ENGINEERING CHANGE NOTICE

1. ECN 128366

5. Project Title/No./Work Order No. CR9603
RMW STORAGE W016

12. Description of Change
DWG H-2-80805 SH 3 REV 0

TYP BARRICADE POST DET

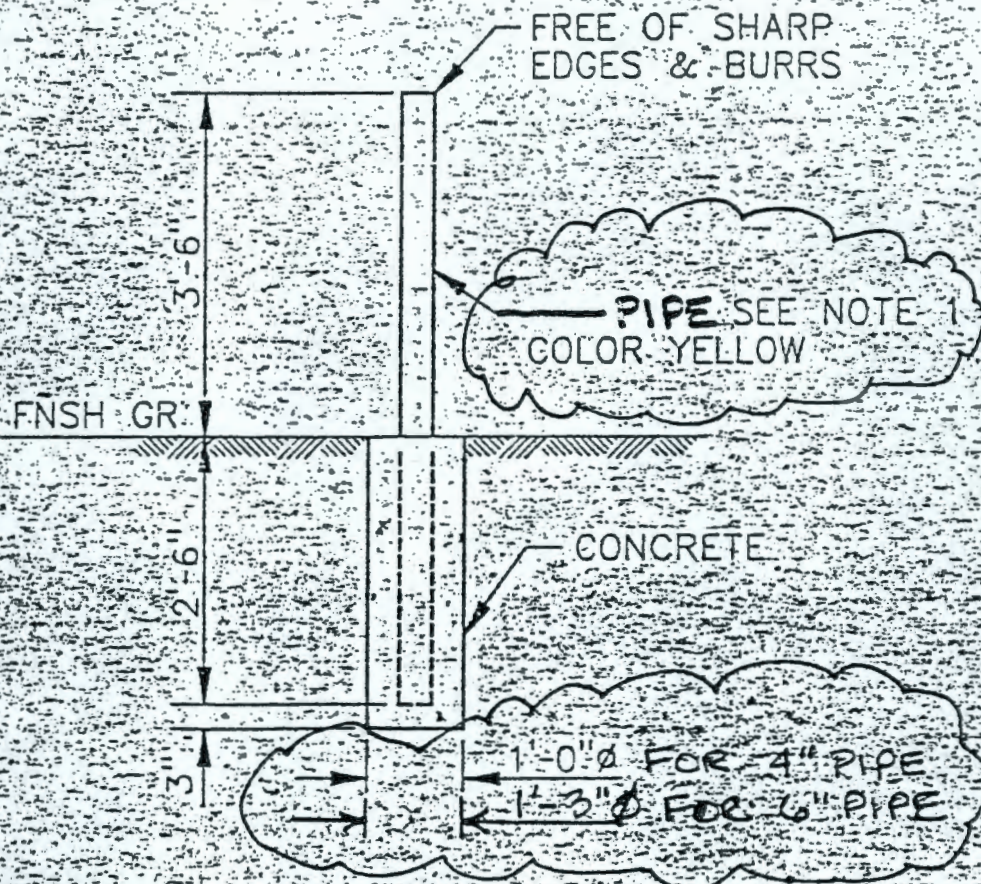
REVISE TYP BARRICADE POST DETAIL AS SHOWN ON PG 3

- " • USE 4" Ø PIPE FOR BARRICADES AROUND PIN 2 ~~AND FIRE HYDRANTS~~ 120
- USE 6" Ø PIPE AT ROLL UP DOORS AT EACH END OF EACH BUILDING TO PROTECT DOOR OPENING FROM VEHICLE DAMAGE. FILL PIPE FULL OF CONCRETE

13b. Justification Details
BOLLARDS AT ROLLUP DOORS PROTECTS THE DOOR FRAME FROM MECHANICAL DAMAGE
- CUSTOMER REQUEST
